VIRGINIA ELECTRIC AND POWER COMPANY
RICHMOND, VIRGINIA 23261

REQUEST FOR ADDITIONAL INFORMATION
REACTOR COOLANT SYSTEM VENTS (ITEM II.B.1)
SURRY POWER STATION UNITS 1 AND 2

REQUEST FOR ADDITIONAL INFORMATION

SURRY 1 & 2

RESPONSE TO VOID IN REACTOR VESSEL (Cont.)

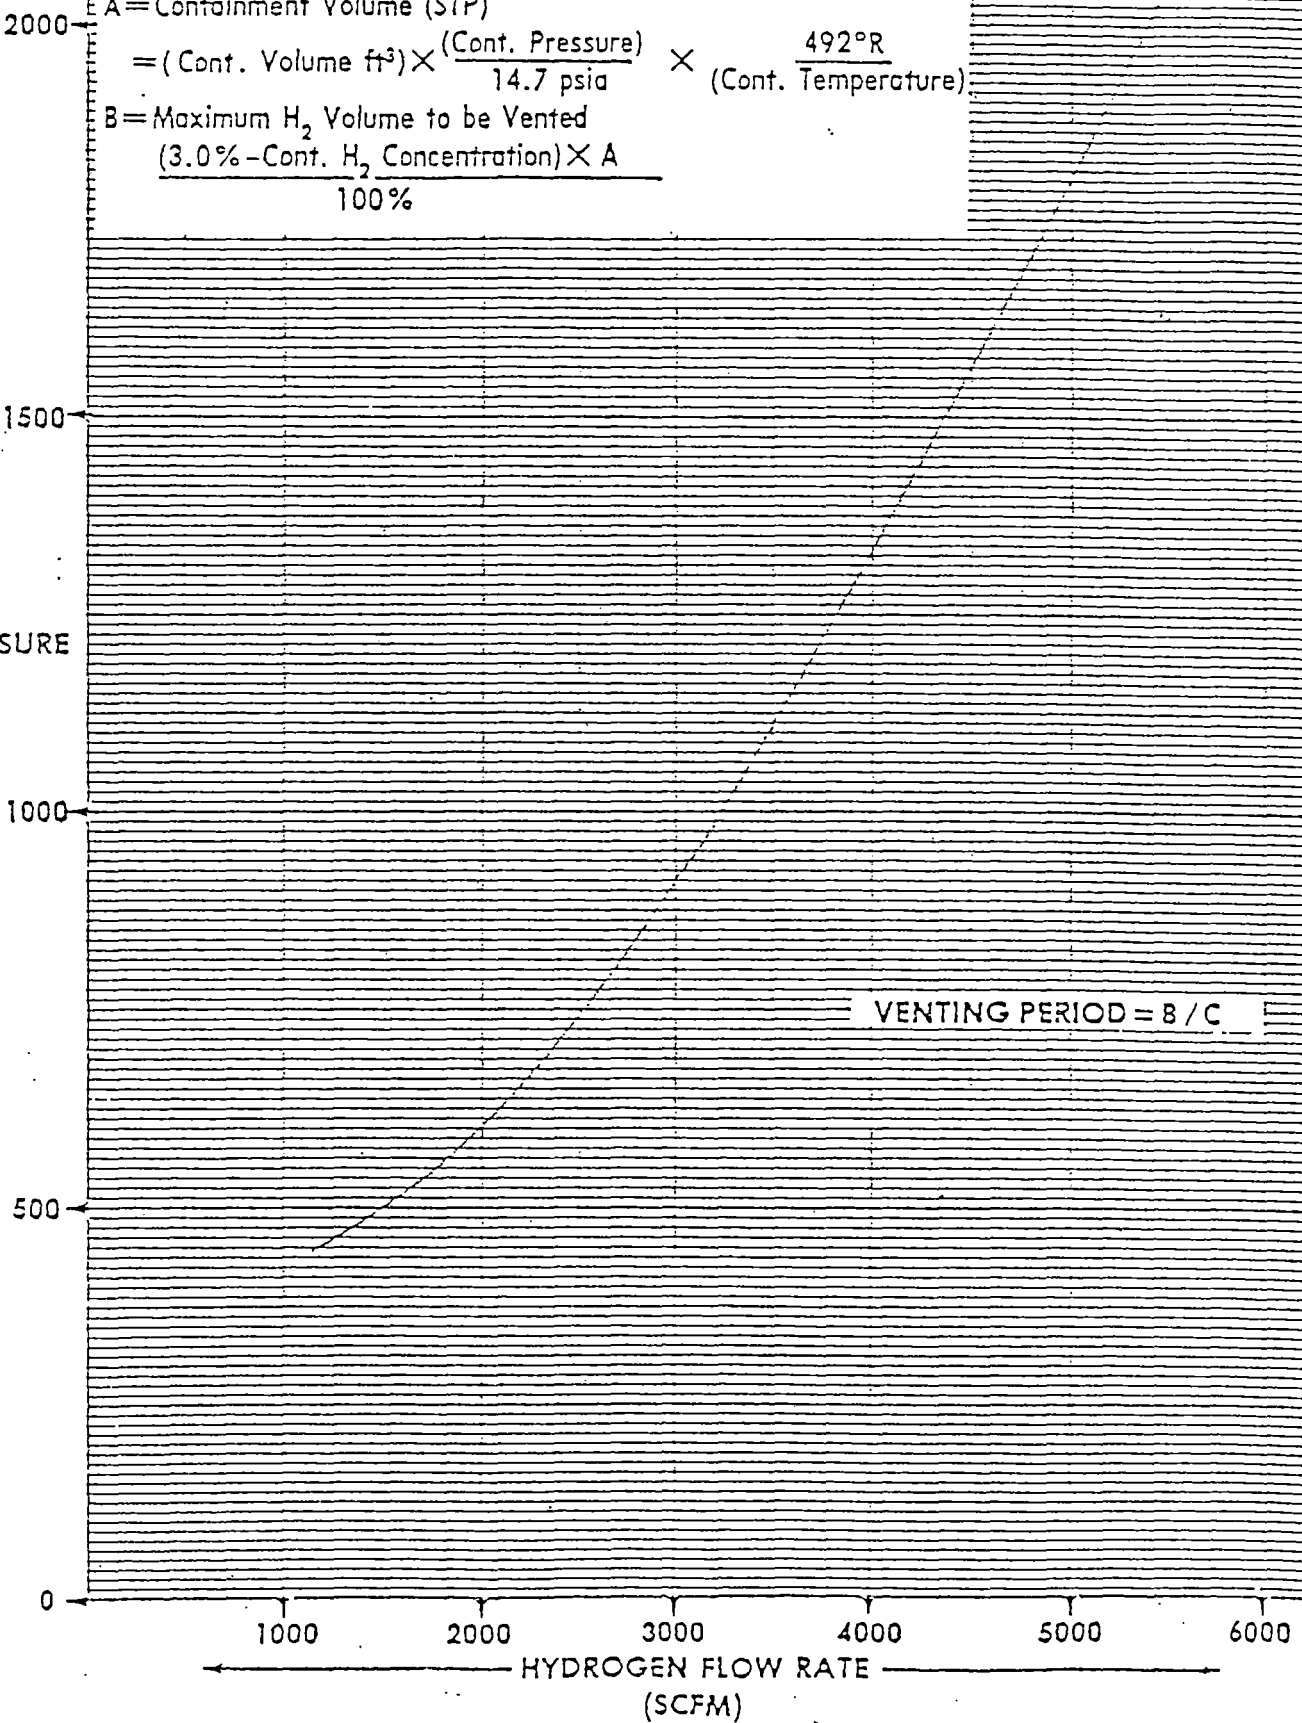
1. Submit operating guidelines for reactor operator use of the reactor vessel head and pressurizer venting system including the following:

- a. Guidelines to determine when the operator should and should not manually initiate venting, and information and instrumentation required for this determination (reference NUREG-0737 Item 11.B.1 Clarification A.(2)). The guidelines to determine whether or not to vent should cover a variety of reactor coolant system conditions (e.g., pressures and temperatures). The effect of the containment hydrogen concentration on the decision to vent or to continue venting should also be addressed considering the balance between the need for increased core cooling and decreased containment integrity due to elevated hydrogen levels.

Hydrogen indication and control equipment are available at present. Step 11 of the guideline addresses containment H₂ concentration and calculation of vent time based on the conservative assumption of the void consisting of 100% Hydrogen. Termination due to Hydrogen concentration is addressed in Step 12.

RCS VENT SYSTEM DISCHARGE POINTS

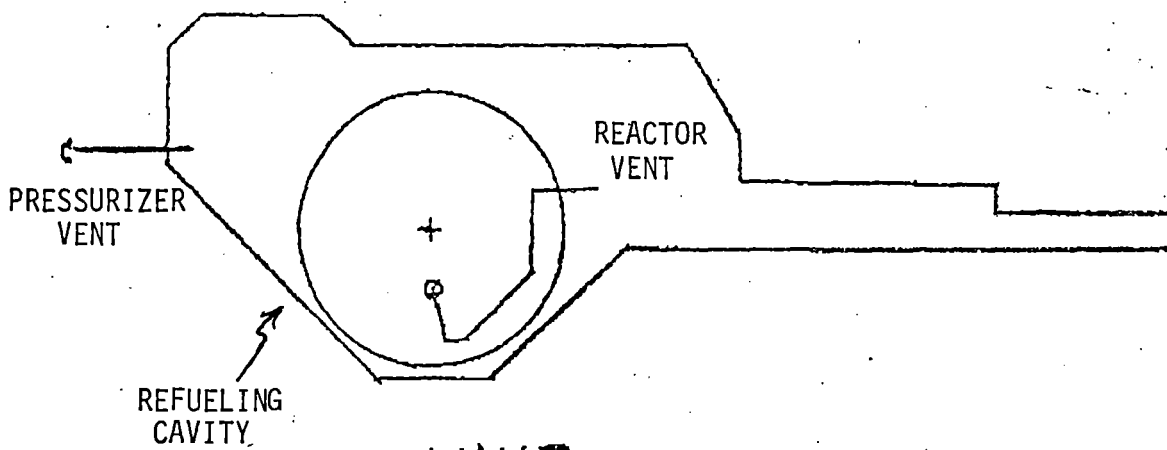
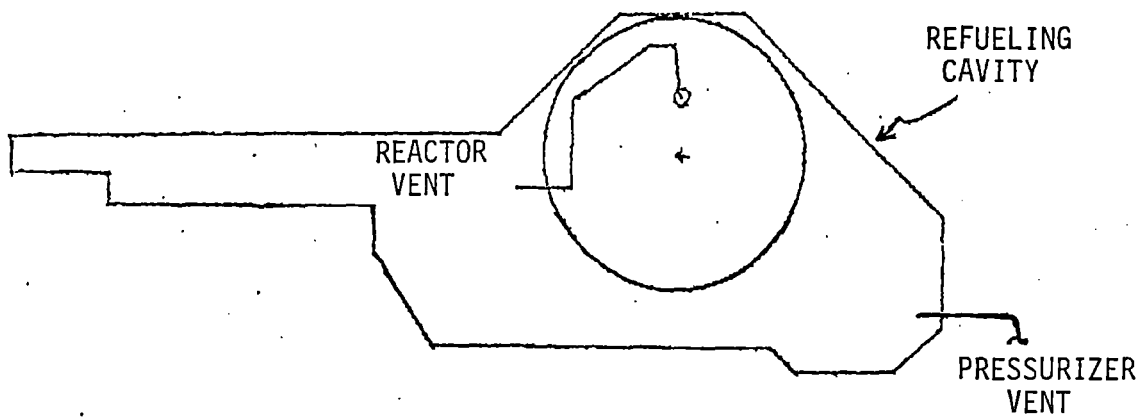
5. Verify that any nearby structures, systems, and components essential to safe shutdown of the reactor or mitigation of the consequences of a design basis accident are capable of withstanding the effects of the anticipated mixtures of steam, liquid, and noncondensable gas discharging from the reactor vessel head and pressurizer venting system.

Response: The spray from both the RCS and Pressurizer Vent Systems are directed into the refueling cavity such that they do not impinge on any components. The pressurizer vent system discharge is directed straight down into the refueling cavity. The RCS Vent System discharge is directed at a 45° angle into the refueling canal from the reactor vessel head. The attached sketch (Attachment III) details the approximate location of the vent system discharge for both units. All components in this area were originally designed or have been qualified to withstand the effect of a LOCA, therefore, no additional analysis need be performed.
